A1 Birtley to Coal House

7.5C Statement of Common Ground: Environment Agency

**STATEMENT OF COMMON GROUND: ENVIRONMENT
AGENCY**

DATE:	28 January 2020	CONFIDENTIALITY:	Public
SUBJECT:	Flood Modelling Response to EA Comments		
PROJECT:	A1 BCH	AUTHOR:	Chris Parker
CHECKED:		APPROVED:	Andy Smith

Figure 1: URBEXT Map

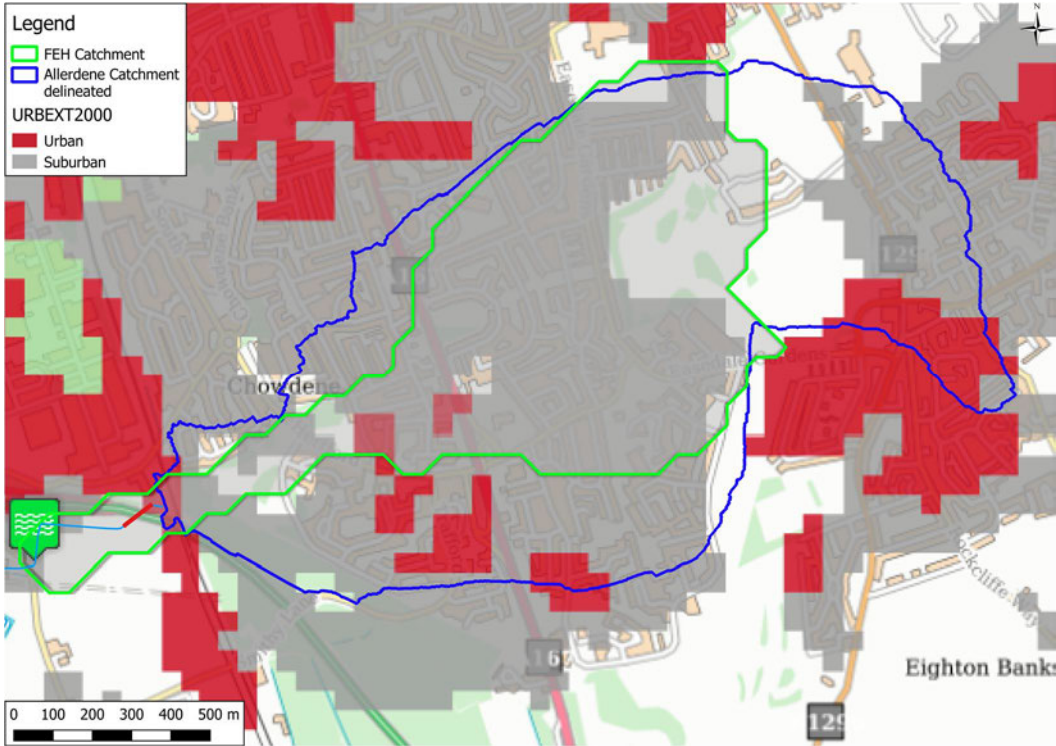
The catchment area has been delineated in GIS and has been compared to the URBEXT coverage, both of which are shown in Figure 1. The catchment descriptors have been updated in line with the identified change in catchment area, these are documented in Table 1

Figure 2 ReFH2 Growth Curves

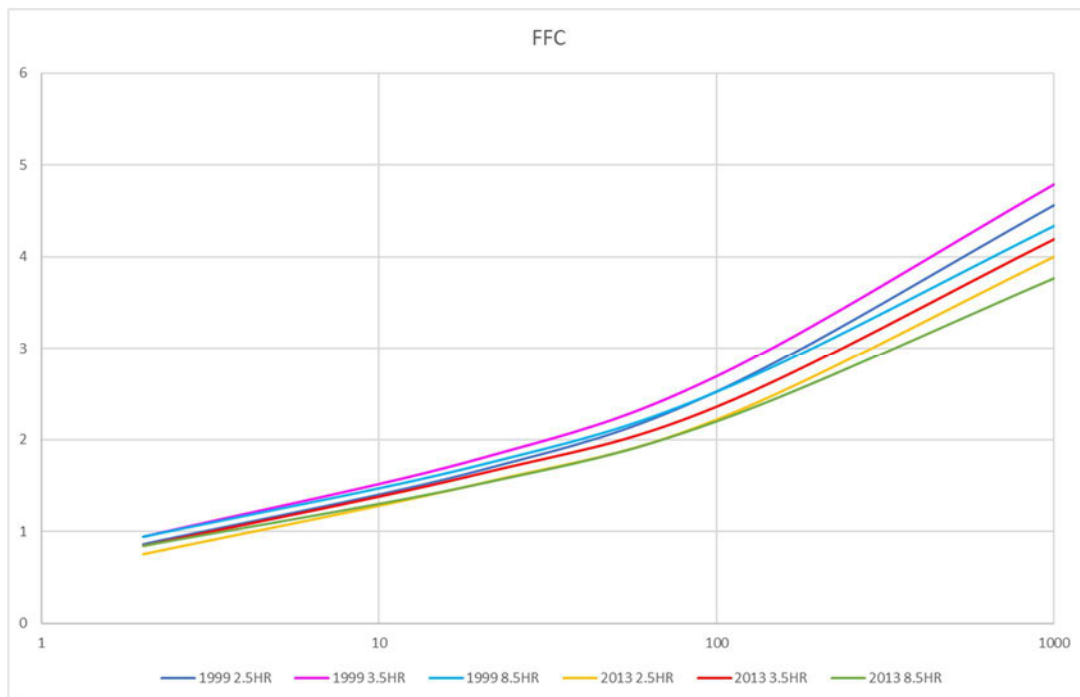
The ReFH2 derived flows have been recalculated (within the ReFH2 software v2.2 and not within ICM) with the refined catchment descriptors as detailed in A-6, the revised flows are detailed in Table 2 and the growth curves in Figure 2, both are below, the key aspects / findings are:

Figure 3: J66 Flood Depths for the 1 in 100 year (1%) event

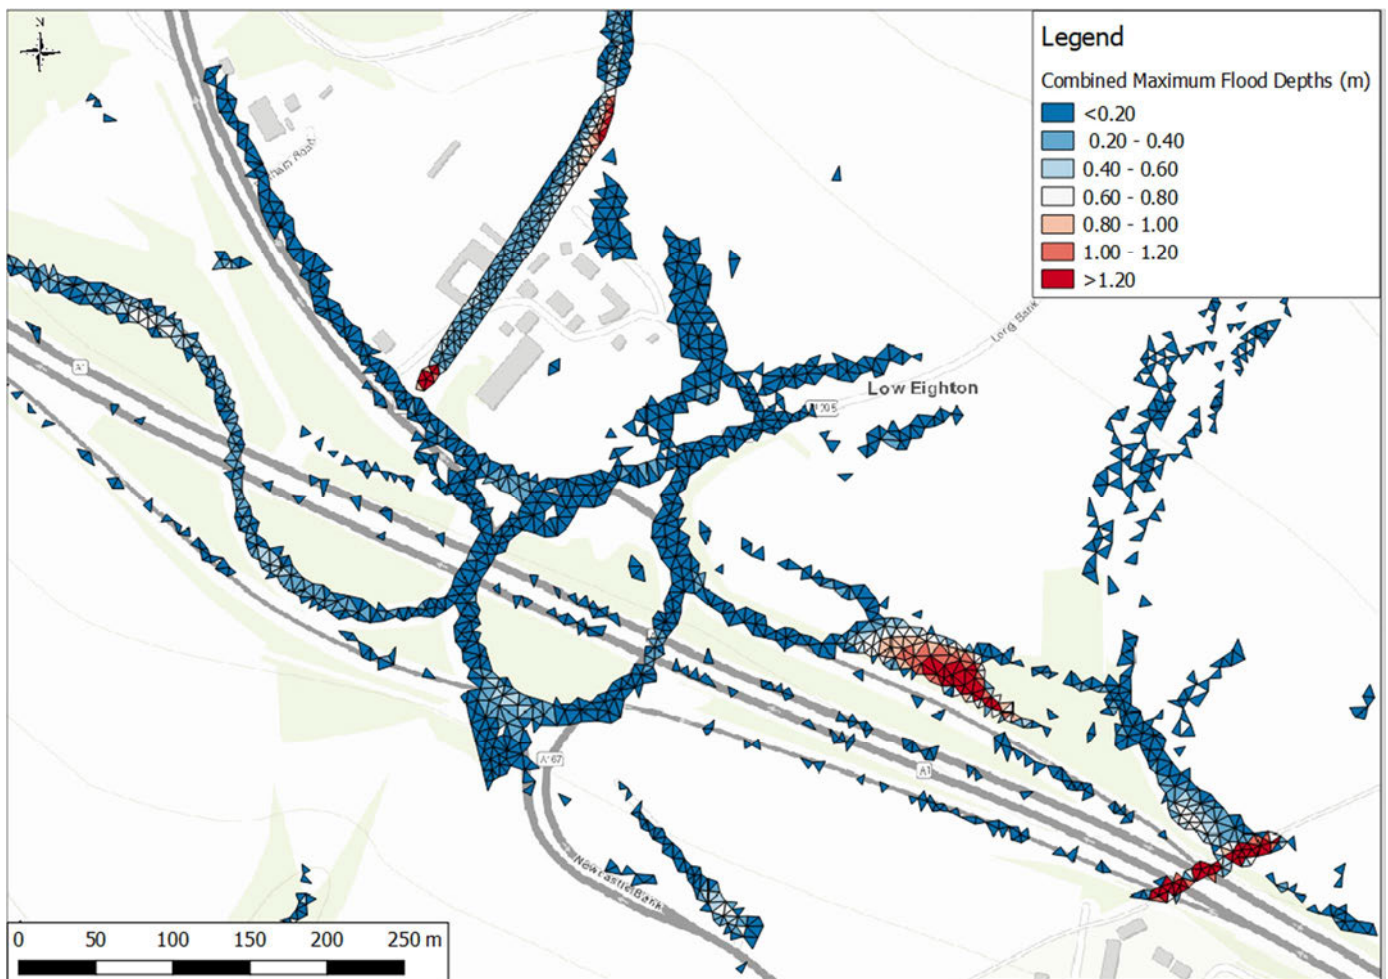
the area of interest. However, as requested all the durations have been run and the results merged to obtain the greatest flood depths. The resultant 1 in 100 year flood map is shown on Figure 3.

Figure 4: Improvements to channel and left bank flows for the Kingsway Viaduct river reach (TEAM_5156.1) because of lowering the bank modular limits to 0.6 (option model)

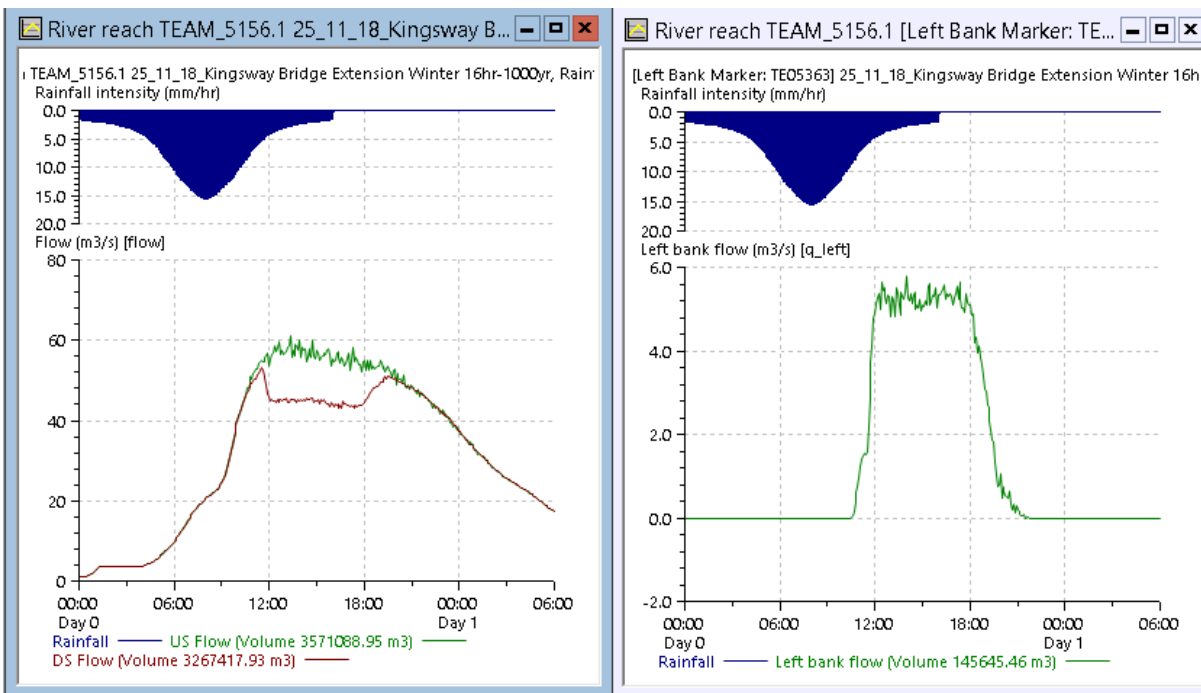
Lowering the bank line modular limit to 0.6 for the TEAM_5156.1 river reach improved left bank flow for the option model, as shown in Figure 4, but caused the original basemodel provided by the EA to fail. The change in modular limit had no impact on in channel flows. The stability problem seems to be a wider issue with the model for example, river reach TE05820.1 directly upstream of the Kingsway Viaduct, shown in Figure 5, shows significant oscillations to in channel and left bank flows. Resolving stability issues with the wider approved and provided Environment Agency model (as developed by JBA) is not required as part of

the evidence base for the Scheme. This is because the A1 is significantly elevated above the River Team and its associated floodplain at this point on a viaduct and the only impacts occur in the future climate change scenarios when the additional bridge piers require a small amount of floodplain compensation (12m³). The model is therefore considered suitable to assess the scale and nature of the proposed impacts.

An attempt was made to improve channel conveyance of river reach TEAM_5156.1 however, this resulted in the model failing to run.

Figure 7: Existing model channel configuration

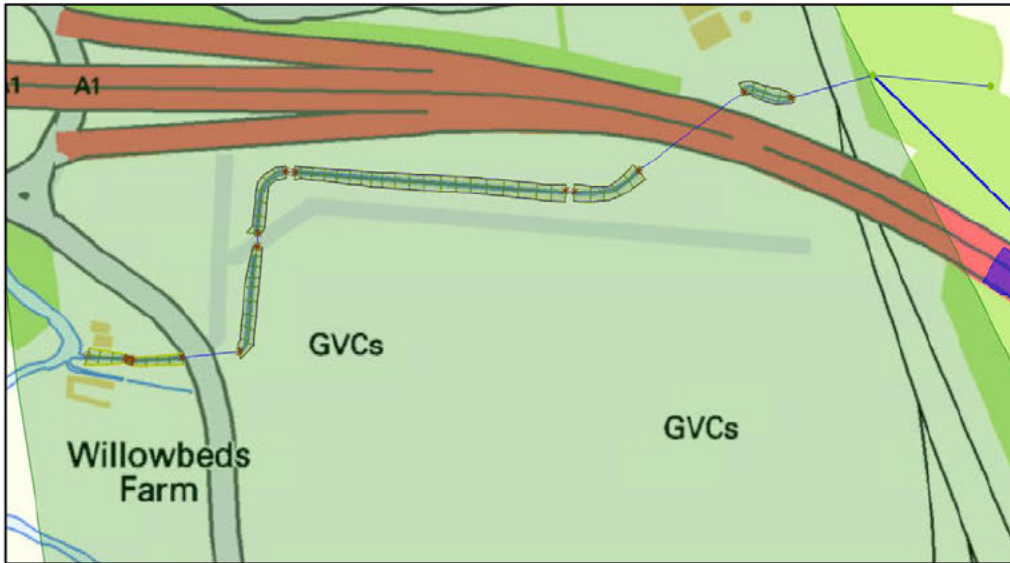
Figure 7 shows the baseline configuration / model schematisation.

Figure 8: Option 1 channel alignment and flow control locations

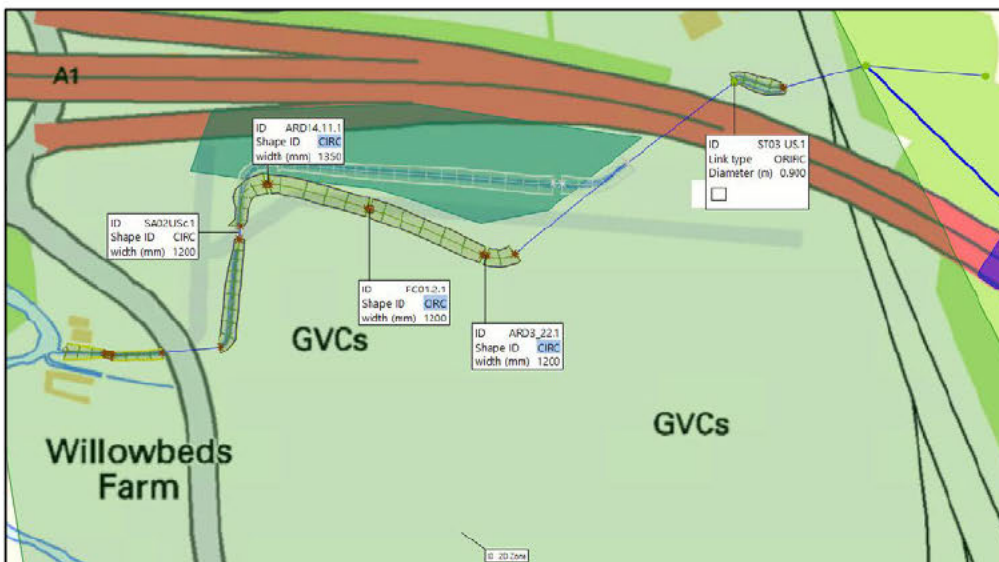
Option 1: requires the extension of the existing Allerdene culvert and realignment of the drainage channel. The proposed drainage channel includes the replacement of four culverts, these are to be replaced with, a 1200mm diameter circular culvert at the downstream end of the channel and a 1350mm and two 1200mm circular culvert at intervals along the channel. In addition, a 900mm diameter circular orifice plate at the upstream end of the existing culvert. These are designed to mimic the existing channel structure, which has three 1350mm culverts, to attenuate peak flows and maximise the available channel storage. The locations and sizes of the flow control structures are shown in Figure 8.

Figure 9: Option 1 channel alignment and flow control locations

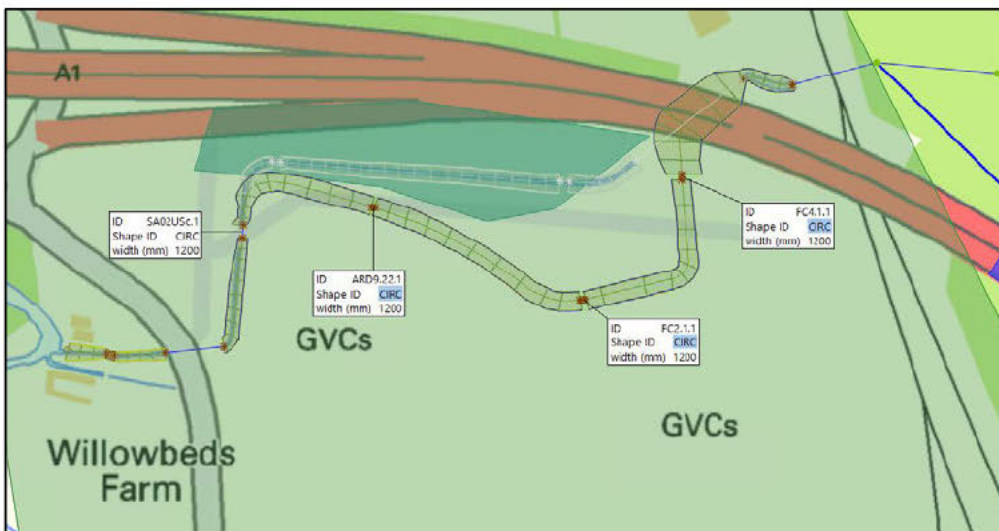
Option 2: Requires the daylighting and replacement of Allerdene culvert with a new section of open channel and realignment of the existing channel to accommodate the construction of a new viaduct over the adjacent railway line. Like Option 1 the new drainage channel includes four 1200mm diameter circular flow control culverts, one at the downstream end and three at intervals along the new channel to attenuate peak flows. Figure 9 shows the alignment of the new channel and location of the flow control culverts.

Figure 11: Flow hydrographs at river reach ST02 DS.1 for 1 in 100 year flows with varying roughness

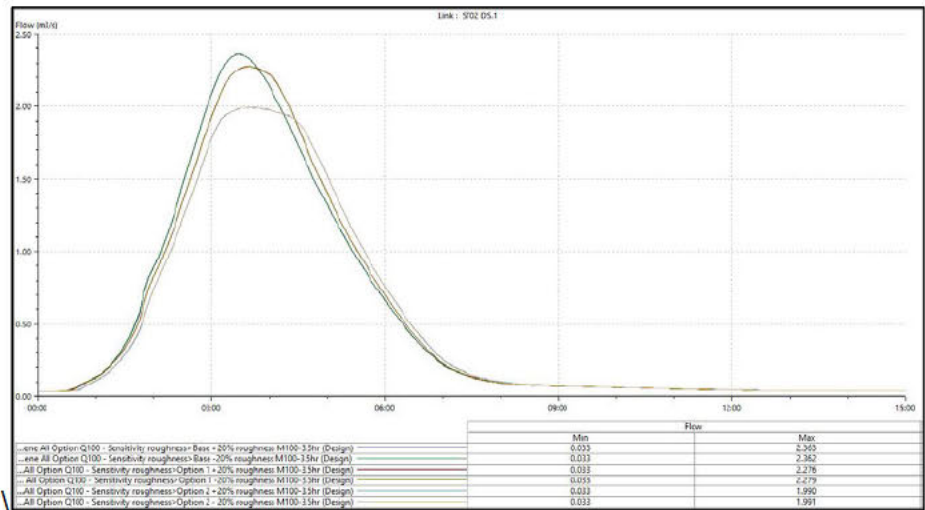
Increasing channel roughness by $\pm 20\%$ has no impact on peak flows (Figure 10). However, for channel depths it does cause the maximum depth to vary by approximately 140-150mm (Figure 11) or approximate ± 70 -80mm compared with the baseline roughness values. This is considered to be within the acceptable model tolerance limits.

Figure 2: In channel flows at TEAM_5156.1

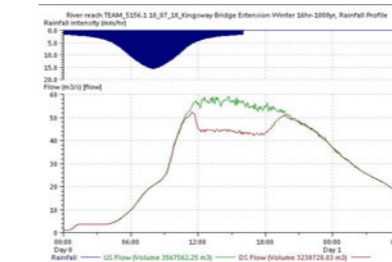
B-140	Total mass error = 9.9 m3	Acceptable		N/A
		B-141	Volume balance error = 0.9 %	Acceptable		N/A
		B-142	There is some oscillation in the peak flows in the area of interest during a 0.1% AEP event (Figure 2)	Minor issue	Make updates to conveyance and bank lines to improve stability	See response to B-29
		B-143	There is some significant oscillations in the out of bank flows in the area of interest during the 0.1% AEP event (figure 3)	Major issue	Make updates to conveyance and bank lines to improve stability. If appropriate, lower bank co-efficient	See response to B-29
	Sensitivity testing	- Suitability of sensitivity testing undertaken - Results & interpretation of sensitivity testing	B-144	Sensitivity tests not provided for review	Minor issue	Run sensitivity tests
Calibration / performance		B-145	No model performance testing was provided for review.	Minor issue	Use the model report to provide commentary on the sensibility of predicted flooding.	This is addressed within the accompanying technical note

Drawing figure 7.6 sheet 2b

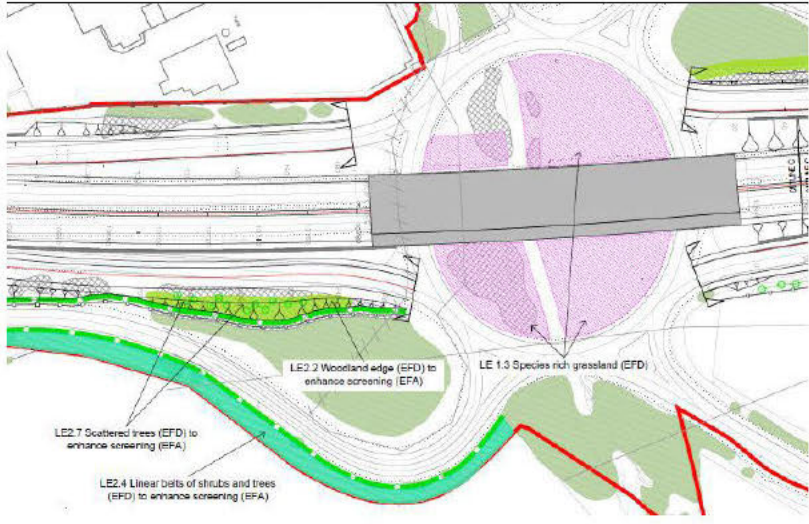
The Applicant must provide flood plain compensation for this new option. It is noted that landscape drawing figure 7.6 sheet 2b, shows no floodplain compensation being given – see drawing below. We would welcome further discussions regarding this matter.

3 Span Option

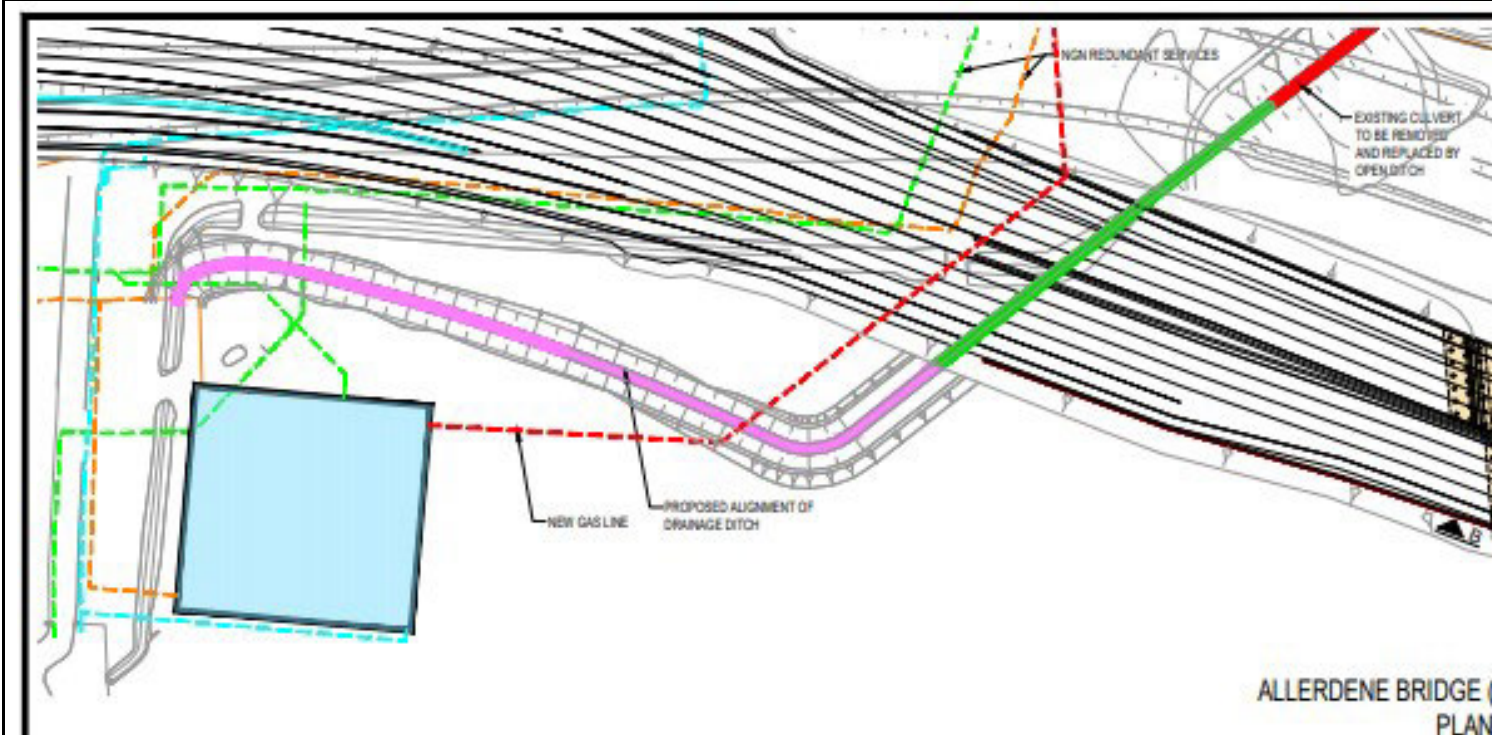
The drawings show that in terms of the Allerdene Burn there is marginal difference between the Embankment Option and the 3 Span Option (although there is some additional channel length for the 3 Span Option) and as we have agreed the works associated with the Allerdene Burn for the embankment option, I was surprised by some of the comments. For clarity the 3 Span Option is a viaduct over the east coast main line but not over the Allerdene Burn. As the two options (embankment and viaduct) have been presented equally in the past, with no preference stated between the 6/7 span or embankment option, the current option cannot be considered a backward step when compared to the assessment previously provided and agreed.

In light of this we do not consider that there is a need to provide additional WFD and biodiversity mitigation for the 3 span option given that the channel relocation is essentially the same as that agreed for the embankment option and likewise there is no requirement to undertake a carbon calculation for the Allerdene Burn as we have not completed this for the agreed designs.
